STAFF RECOMMENDATION

412 Broadway

Application: New construction - addition

District: Broadway Historic Preservation Zoning Overlay

ROOF PLAN

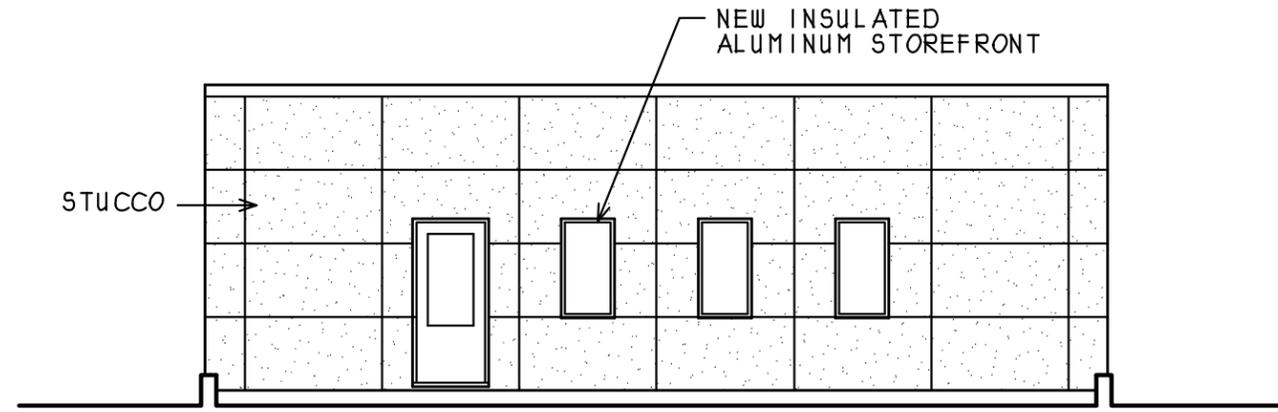
The plans also indicate that a railing for a roof deck may be added in the future, but that it is not part of the current scope of review. The railing would sit back eight feet (8') from the front of the building. In a past case, the Commission determined that eight feet (8') is an appropriate setback for railings associated with rooftop additions. Additional information on this railing and roof deck would need to be submitted at that time for administrative approval.

The mechanical systems will be located on the third story roof, behind a parapet wall so as to screen them from public view.

1. Windows and doors be approved by staff;
2. Plans for any future roof deck and railing or lighting and signage are submitted for review and administrative approval; and,
3. The existing windows be assessed to determine if they should be repaired or may be replaced. Replacement windows, if appropriate should retain the double-hung design.

FRONT ELEVATION ON BROADWAY

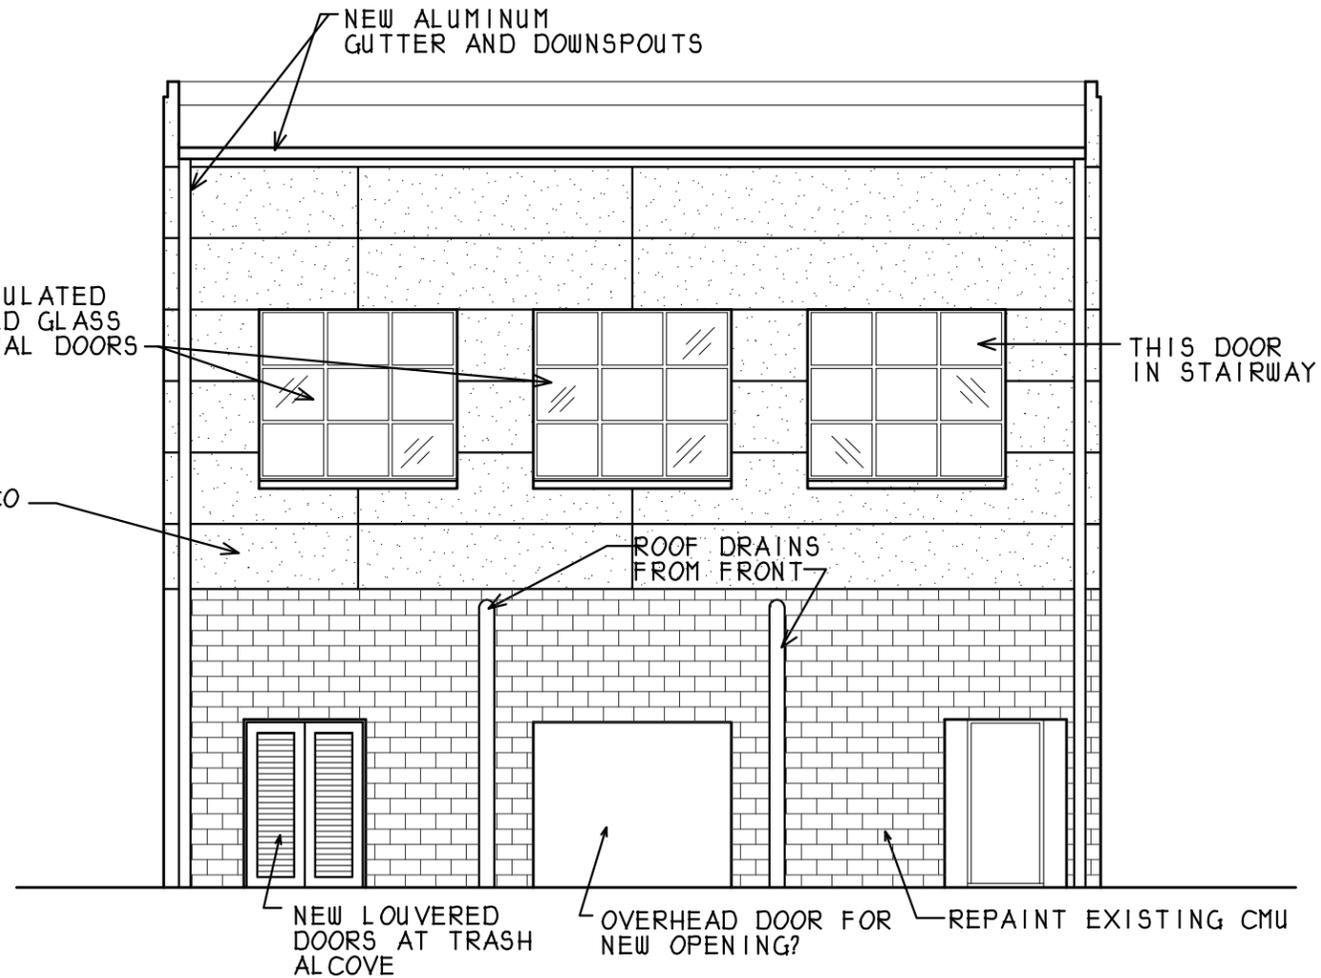
The addition will sit back thirty feet (30') from the front wall of the building, extending all the way to the rear of the structure. The addition will be above the two left thirds of the building with a front wall twelve feet (12') taller than the existing front parapet. This is subordinate to the existing structure, for which the first and second stories are seventeen feet (17') and sixteen feet (16') tall, respectively. The height of the addition is appropriate and meets the design guidelines, which require that rooftop additions be no more than one-story. This location is also appropriate because it will not alter the appearance of the building from the street, nor will it obscure or destroy any character-defining features or materials.

The louvered panels over the second story windows will be removed. The windows will be assessed and, based on their condition will either be repaired or replaced with aluminum-clad windows, matching the size and proportion of the original windows. The windows may function as casements, but will need to have the appearance of historic double-hung sashes with a meeting rail.

REAR ELEVATION

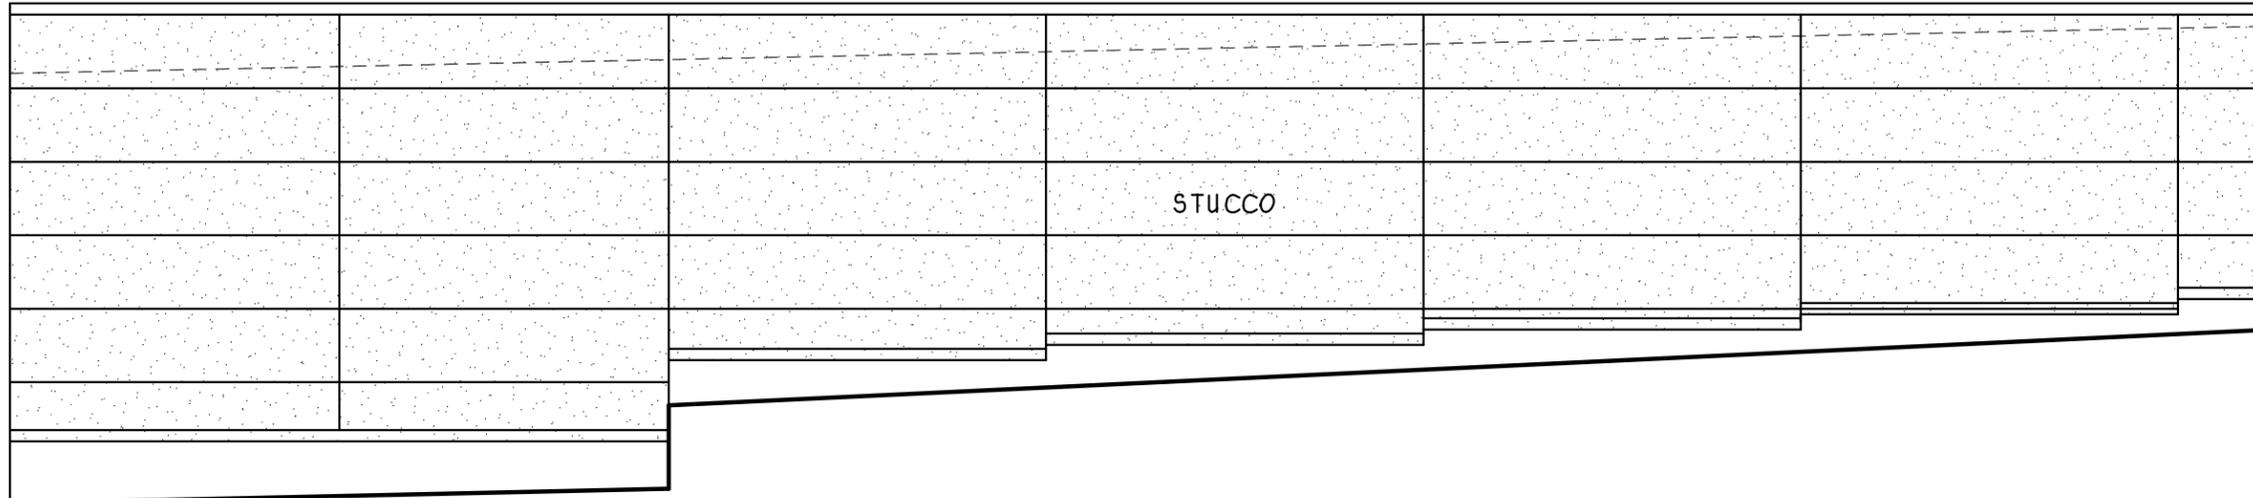
At the rear of the building, the rear wall of the addition will stack directly above the existing rear wall, increasing it from thirteen feet (13') tall to thirty-one feet (31') tall. This location is appropriate because the addition is only one story tall from the front, and because there is little on the rear elevation that is original to the building and there are no defining historic features.

The exterior walls of the addition will be stucco, with aluminum store-front type doors and windows. The rear elevation will have aluminum sectional windows/doors.
